TG5/SAR Meeting
ODIN: Status of NCR's and NIT's

ODIN - SAR

Status of NCR's and NIT's

NCR 10527

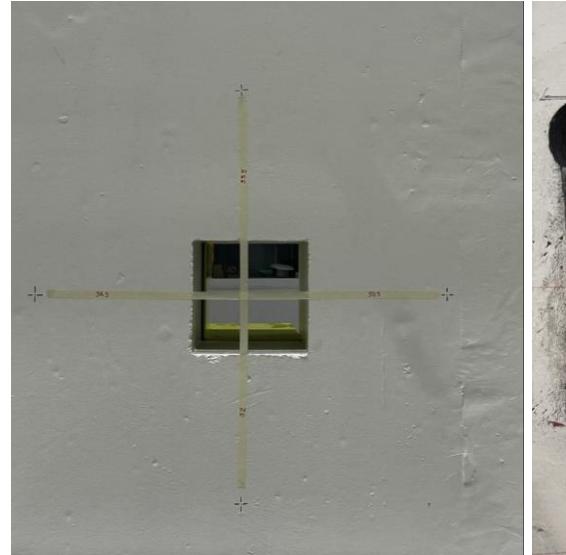
Based on https://jira.ess.eu/browse/SAM-62, the opening in the back wall was not exactly aligned with the direct beam (or where we expect the direct beam to be), we had to enlarge the hole slightly. This enlargement ensures that the beam will hit the beam stop and not the wall.

Regarding NC 10527: back when the opening was made, we have visited the ODIN cave together with Radiation Protection (Ana Cintas) and with Günther Muhrer (Group Leader, ESS Spallation Physics). The situation was reviewed on site, focusing on the enlarged opening in the back wall and the alignment with the beam stop.

Since the size, material and position of the beam stop itself have **not** been changed, the adjustment to the wall opening only affects the instrument performance – in a positive way – by ensuring that the full direct beam is intercepted by the beam stop instead of partially hitting the wall. From the shielding and safety perspective, the change does **not** introduce any negative impact; on the contrary, it helps to minimise unnecessary neutron activation inside the cave.

Based on this, we consider the non-conformity to be addressed and controlled.

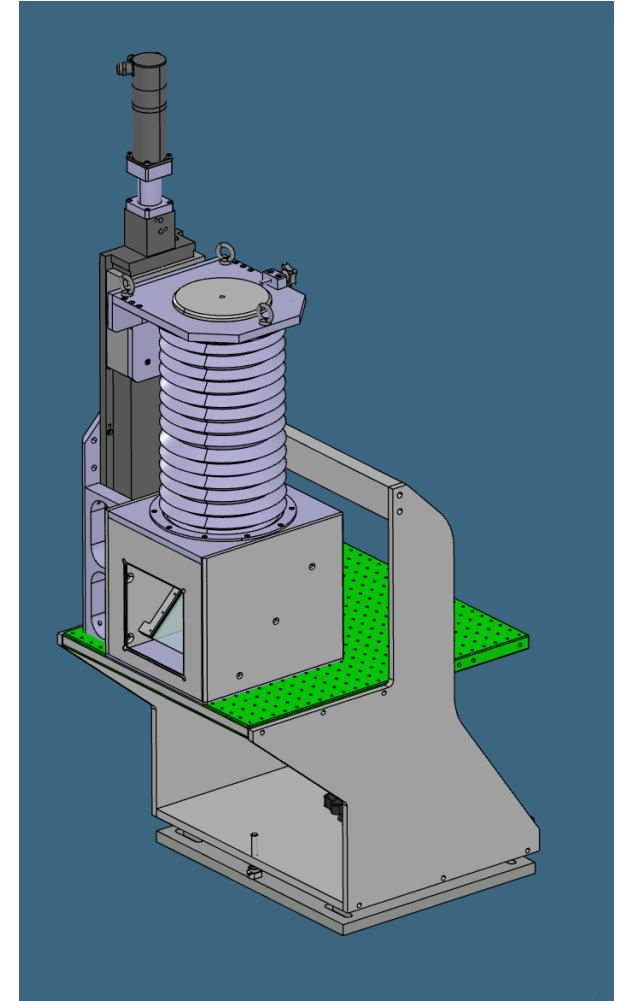
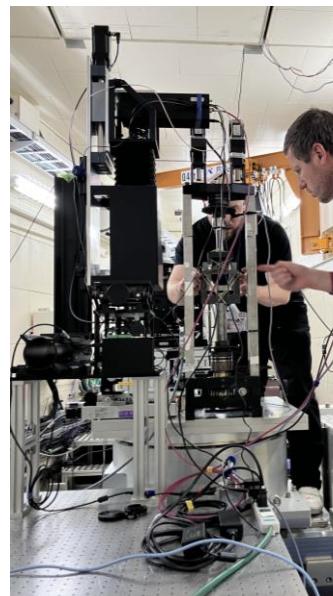
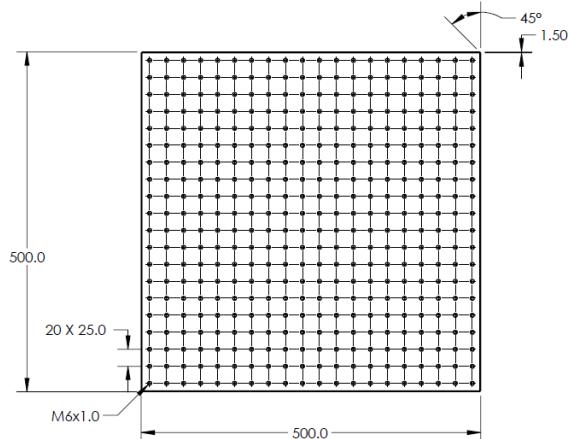
- The ODIN ToF detector did not fit reproducibly on the detector table plate
- A suitable plate has been designed and ordered

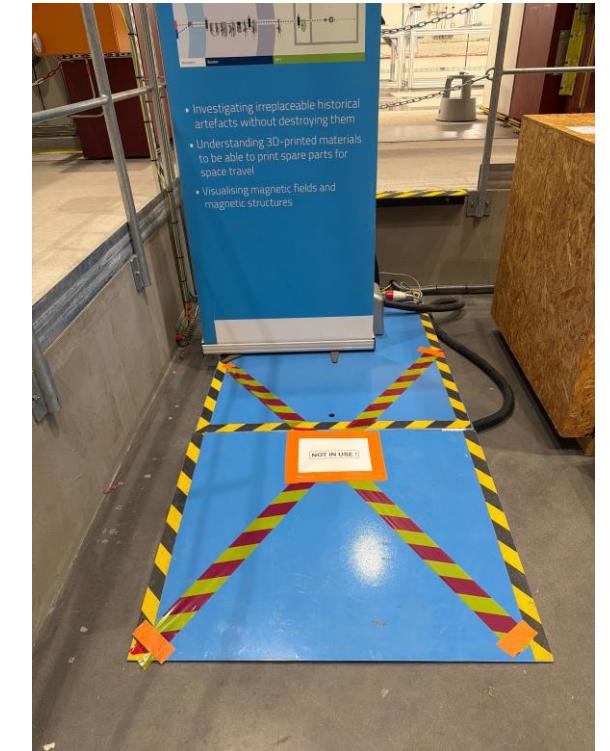
- Lifting platform was deemed potentially unsafe (despite passing all prior reviews)

- In any case, the instrument prefers to not have it:
  - Was never needed during installation as ramp is available.
  - Access can be better be used by fork lift if something that heavy comes in

The platform has been marked with 'NOT IN USE' by Richard Ammer (until it will be removed later).
